Application No. 09/938,947  
Amendment and Response dated July 16, 2004  
Reply to Office Action of March 16, 2004

### **REMARKS/ARGUMENTS**

Fig. 9

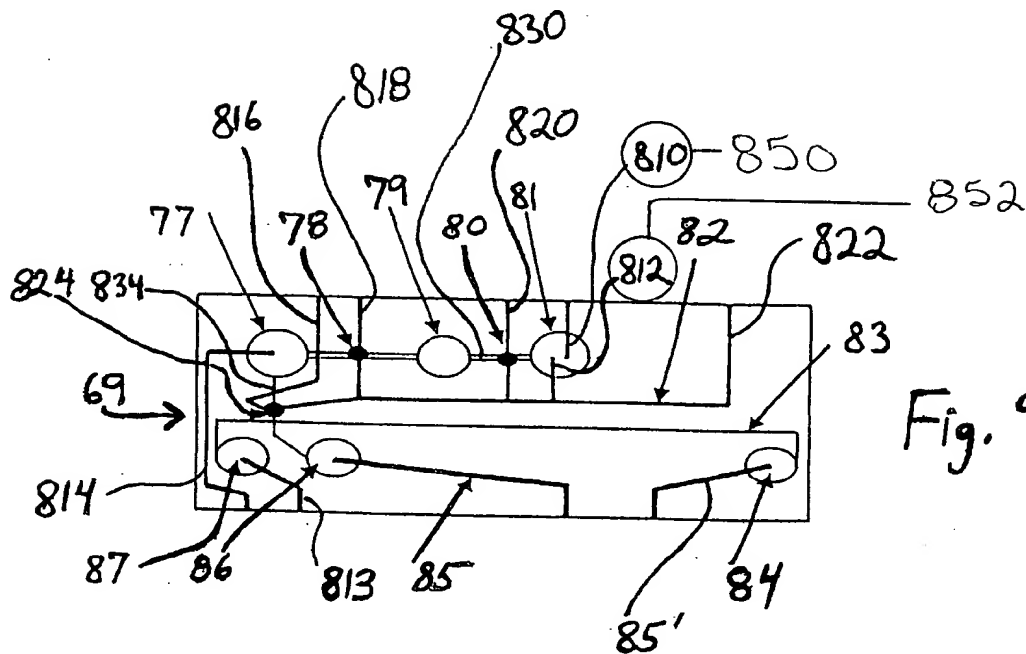
Fig. 9 has also been objected to by the Examiner for including duplicate reference signs **810** and **812** in the figure. Applicants have addressed this objection by a proposed drawing correction to change reference characters **810**, **812** in Fig. 9 to **850**, **852**, as described in the amended specification at page 36, line 2. Withdrawal of this objection to the drawings is respectfully requested.

The drawings have been objected to for failing to comply with 37 C.F.R. § 1.84(p)(4) because reference characters **810** and **812** have been used to designate two different features in the figures. Applicants have addressed this objection by redesignating **810** and **812** in Fig. 9 with new reference numbers **850** and **852**, respectively. Withdrawal of this objection to the drawings is respectfully requested.

Fig. 19

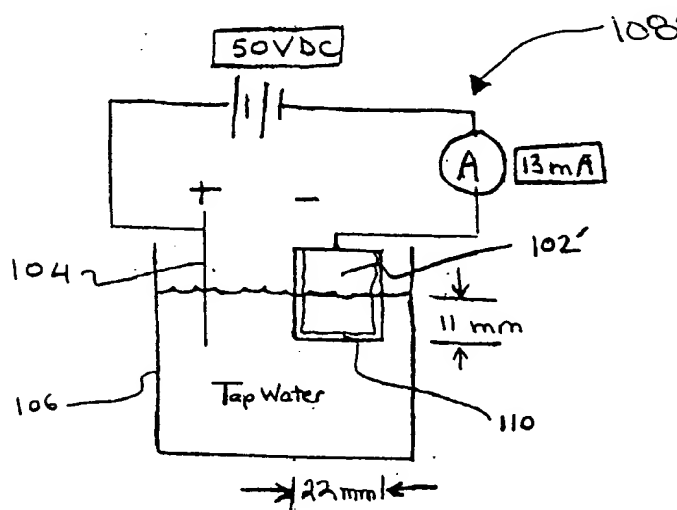
Fig. 19 has been objected to for including a reference sign **110** which is not mentioned in the specification. Applicants have addressed this objection by the above revision to the specification at page 48, line 7 to indicate that reference sign **110** is directed to an insulating border made of epoxy. No new matter has been added by this amendment to the specification. Withdrawal of the objection to Fig. 19 is requested.

The drawings have been objected to for failing to comply with 37 C.F.R. § 1.84(p)(5) because they do not include reference signs **802** and **108'**. Applicants have addressed the objection to reference sign **802** through the above amendments to the specification at pages 33 and 34. The objection to reference sign **108'** has been addressed by the correction to Fig. 19. Withdrawal of these objections is respectfully requested.
